# MONITORING YEAR 5 ANNUAL REPORT

## CANDY CREEK MITIGATION SITE

RE: **Draft Monitoring Year 5 Report Comments  
Candy Creek Mitigation Site (DMS #96315)**  
Cape Fear River Basin 03030002, Guilford County  
Contract No. 005794

Figure 3.6 Integrated Current Condition Plan View  
 Candy Creek Mitigation Site  
 DMS Project No. 96315  
 Monitoring Year 5 - 2021  
 Guilford County, NC

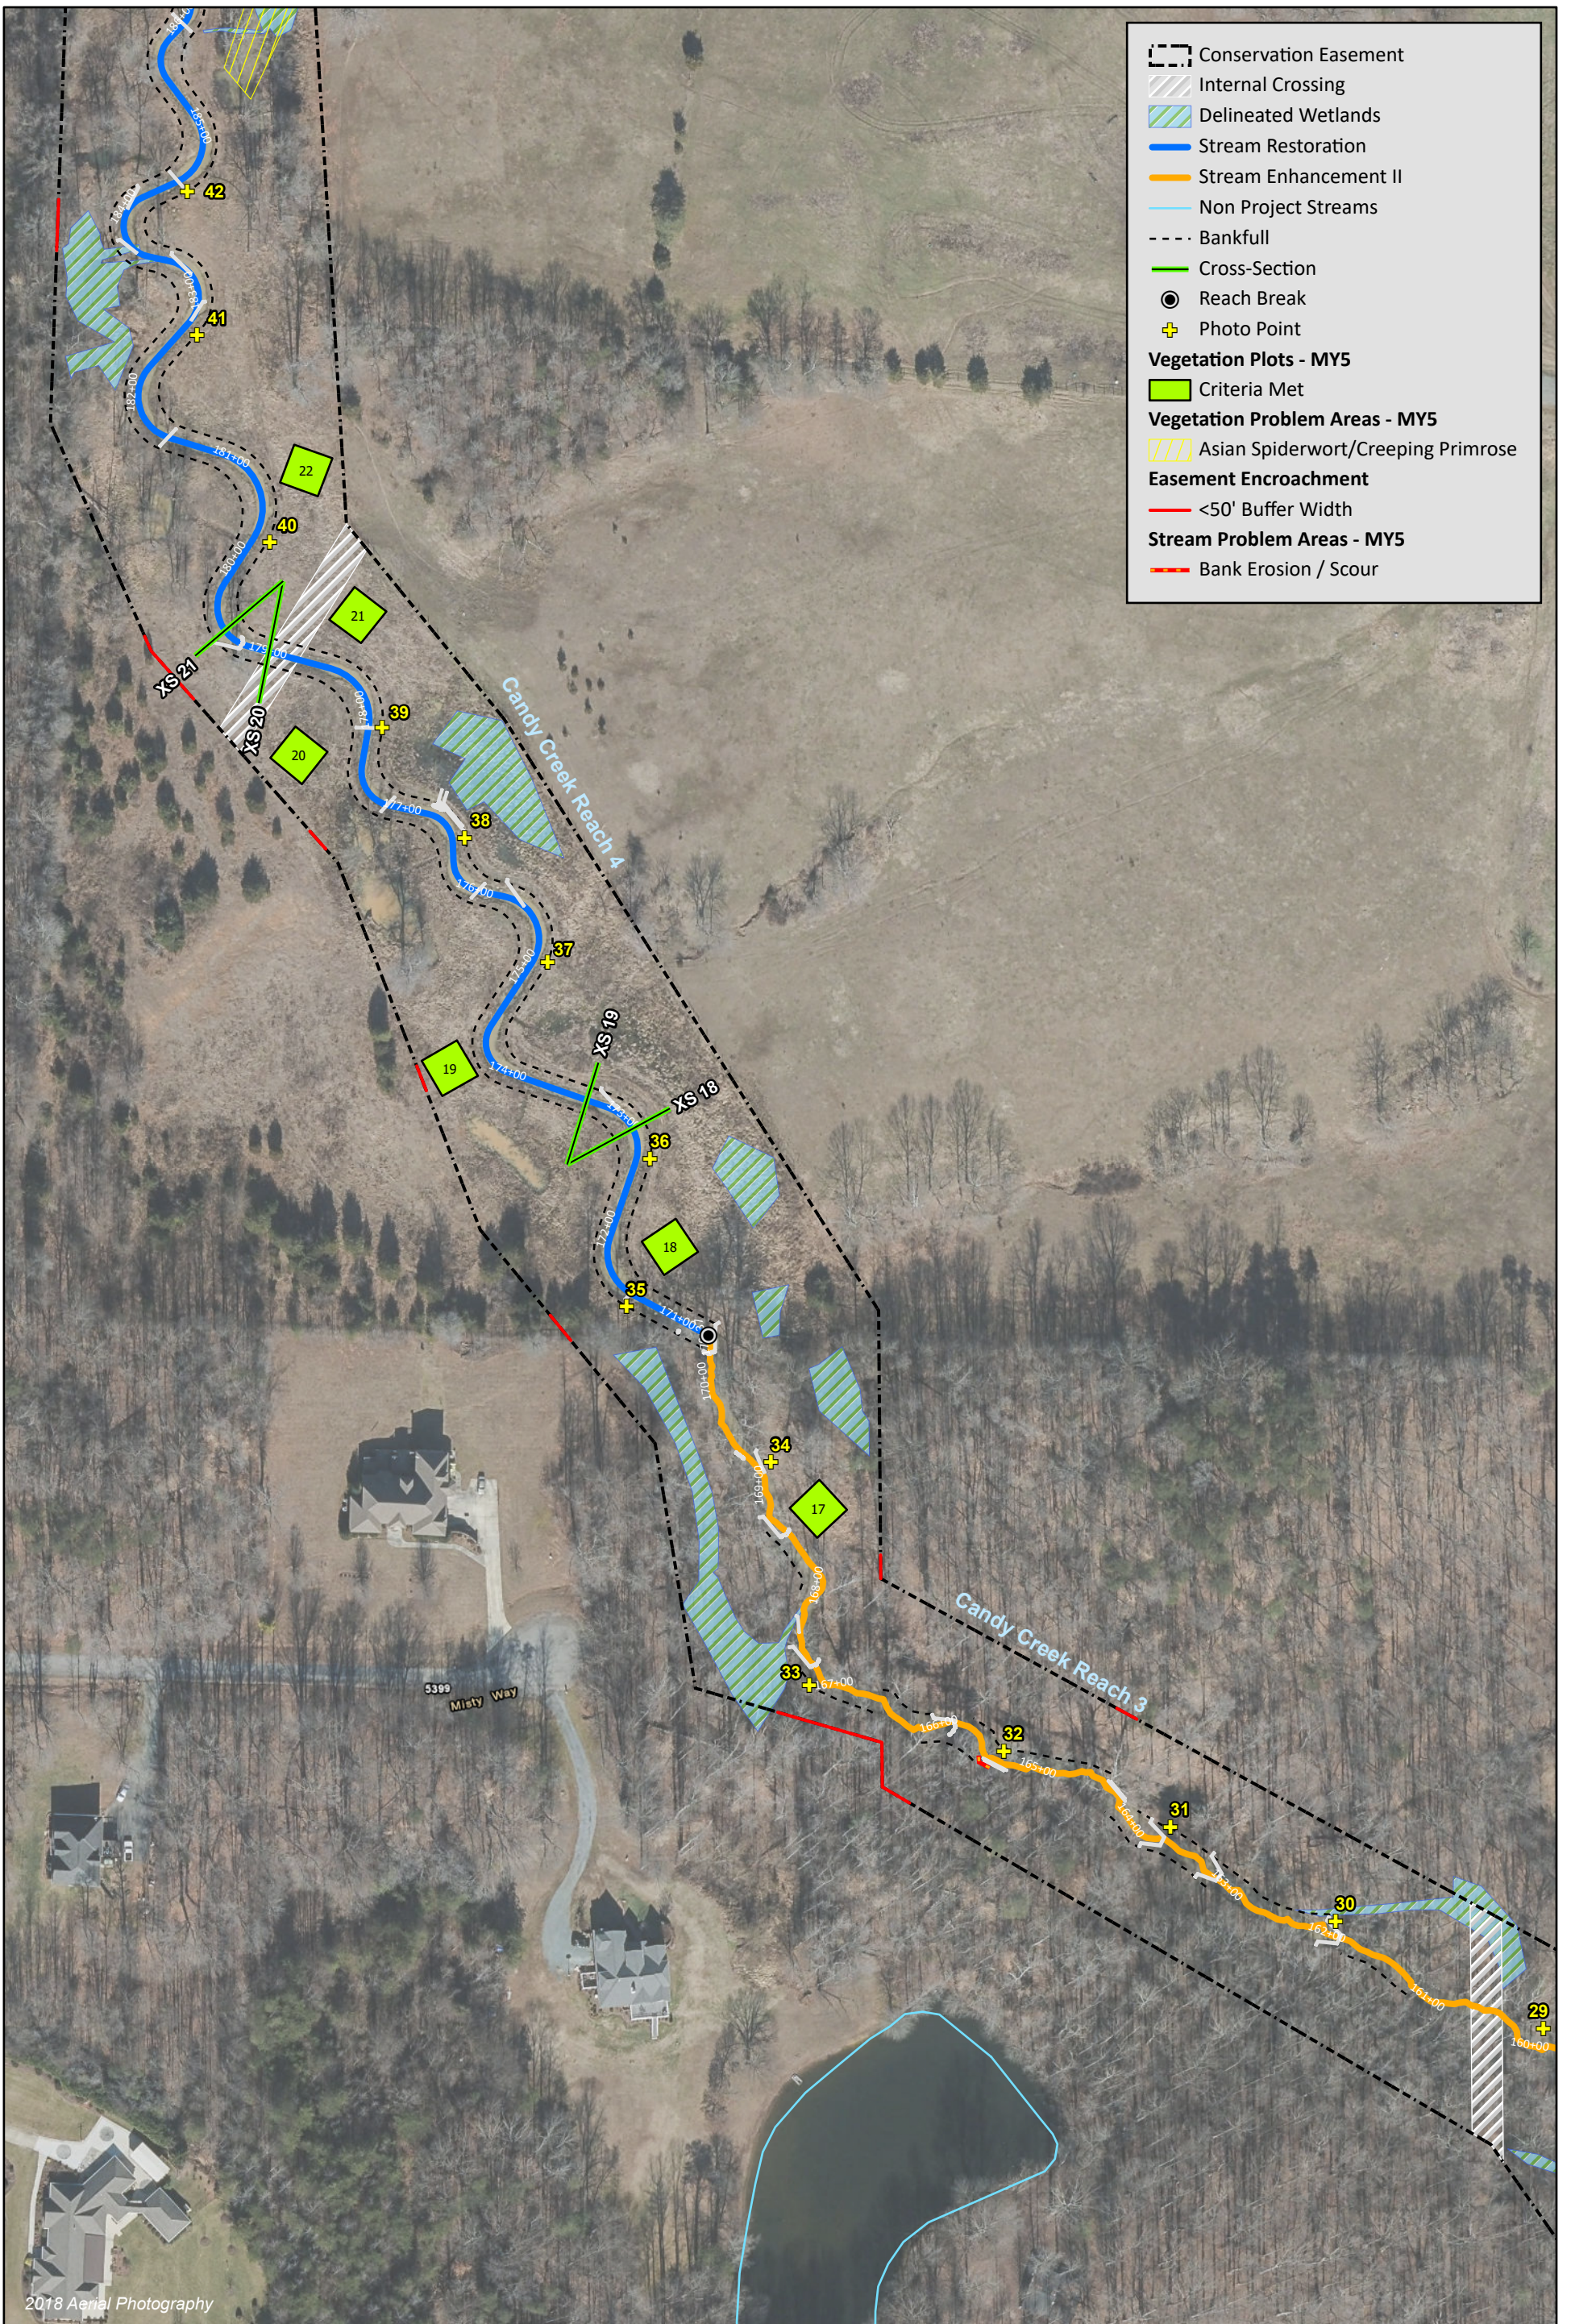
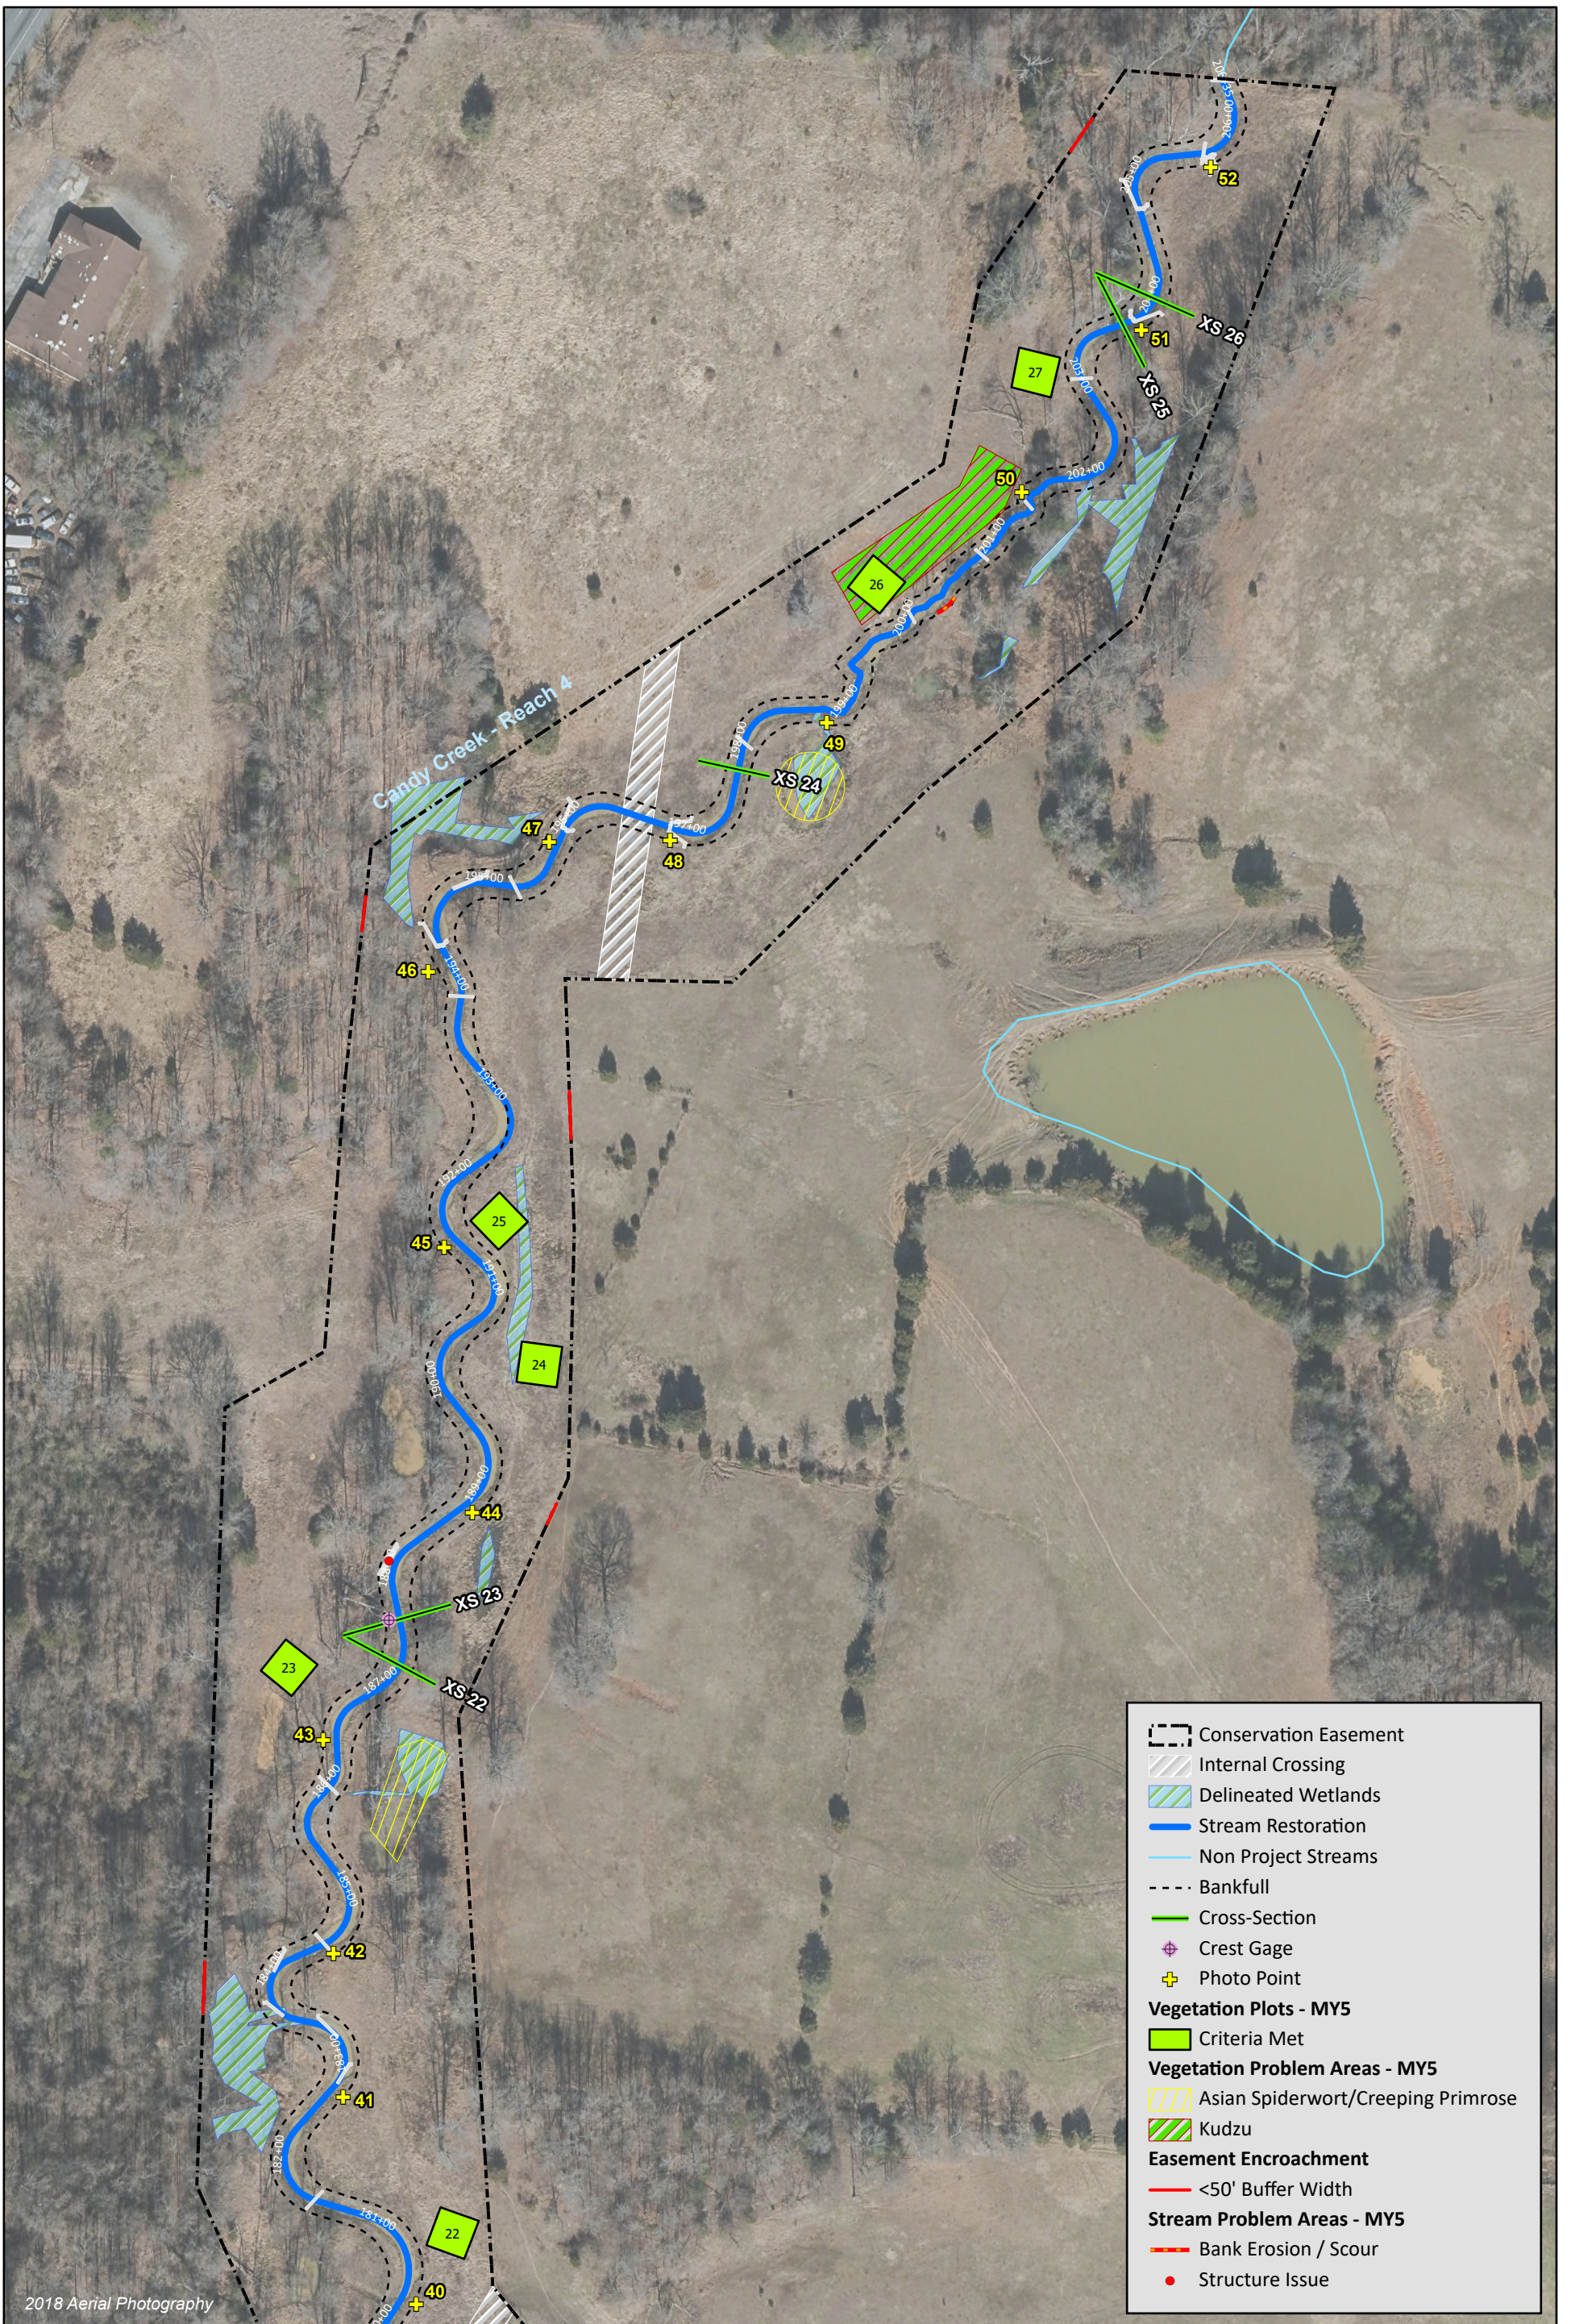
- a. **Please ensure that the stream areas of concern values reported in Table 5 reflect the submitted spatial data. For example, there are 2 aggradation features submitted for UT5 with a combined length of 130 ft, whereas Table 5m reports 3 segments with a length of 110 ft.**

*Wildlands' response: The submitted geodatabase, the associated figures (Figures 3.0-3.7), and the associated assessment tables (Tables 5a-5m) were checked and corrected so that the feature counts now match. For example, Table 5m now reports 2 segments of aggradation totaling 130ft, as shown in Figure 3.1; and the one structural issue for Overall Integrity on Candy Creek Reach 4 is now drawn on Figure 3.7. Where bed or structure issues overlap with an existing issue, notes were added to the attribute tables rather than adding additional features to the maps. For example, one of the aggradation issues mapped on UT4 and shown in Figure 3.2 and Table 5l, corresponds to two riffle condition-substrate and 1 pool condition-depth issues, which is now indicated in the attribute table.*

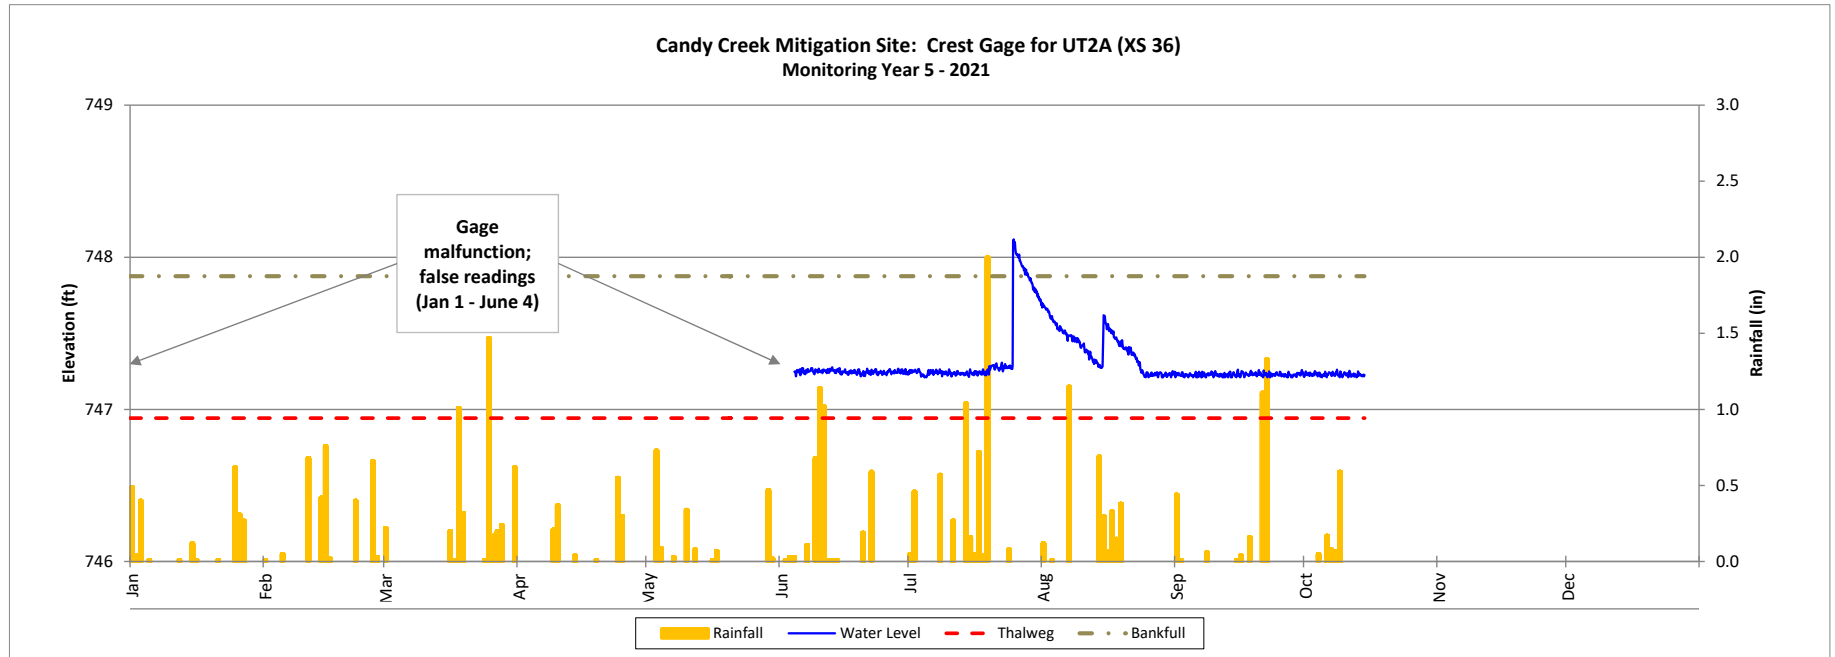
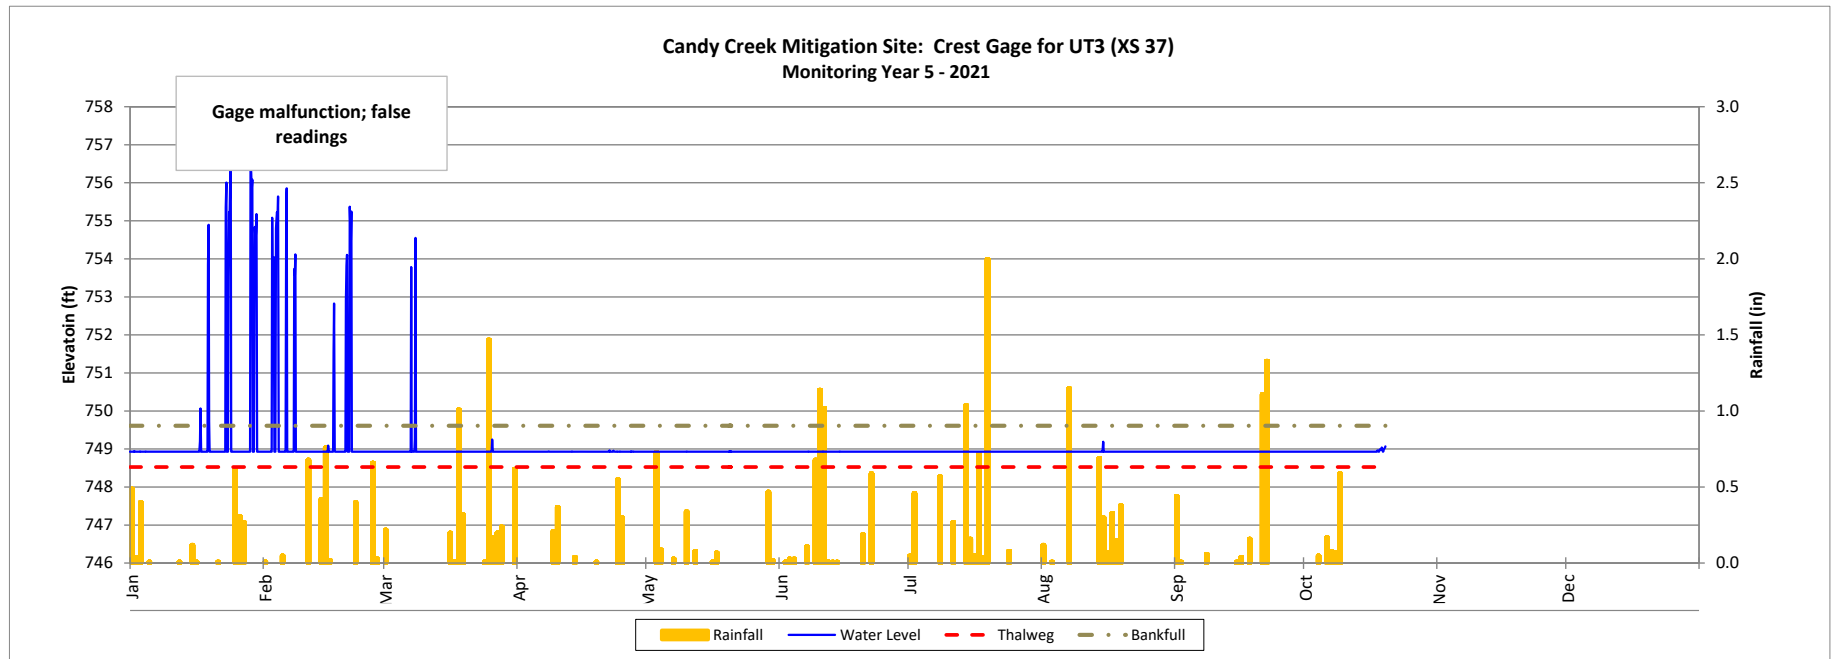
**DMS' comment: Section 1.2.4 Hydrology Assessment: Please address the gage repair as soon as possible to support the MY6 monitoring. Include a summary of the gage status in the upcoming repair summary in preparation for the credit release meeting.**

*Wildlands' response: The gages on UT1D and UT2 were replaced in 2021. Wildlands will check the calibration of each probe in 2022, early in MY6. The results of the calibration check (and the repairs discussed below) will be described in a written summary that will be sent to DMS for inclusion in the report before it is submitted to the IRT for the Credit Release Meeting. Section 1.2.4 Hydrology Assessment was updated and now describes this process.*

\*Due to the large spikes that do not seem to correlate with rainfall amounts, but occurred only during the winter months, Wildlands pulled air temperature data for the surrounding area and noticed a correlation between the spikes and when the air temperatures dropped below freezing. Therefore, Wildlands contacted In-situ on 11.18.21 to gain some technical insight on these findings. A Technical Support Specialist, Kaylie Haynes, at In-situ confirmed that these spikes are likely false readings due to freezing water around the pressure diaphragm in the gage. She referred us to specification sheet for the pressure transducers, Rugged TROLL(R) 100 Data Loggers, that Wildlands commonly uses in the field (2021). Therefore, Wildlands ignored the bankfull event spikes recorded from 01.01.21 - 04.01.21, when air temperature is more likely to fall below freezing, and only included bankfull events recorded between 04.01.21 - 10.31.21 when air temperature is more likely to remain above freezing and that positively correlated with rainfall amounts from the nearest rainfall gage. Moving forward, Wildlands will check the calibration on the gages using a known depths of water. If the gage is recording correctly, it will be reinstalled for use in 2022. If the gage is not recording correctly, Wildlands will refrain from using the gage unless it can be refurbished by In-situ, upon which Wildlands will check the calibration before reinstalling it for use during 2022.
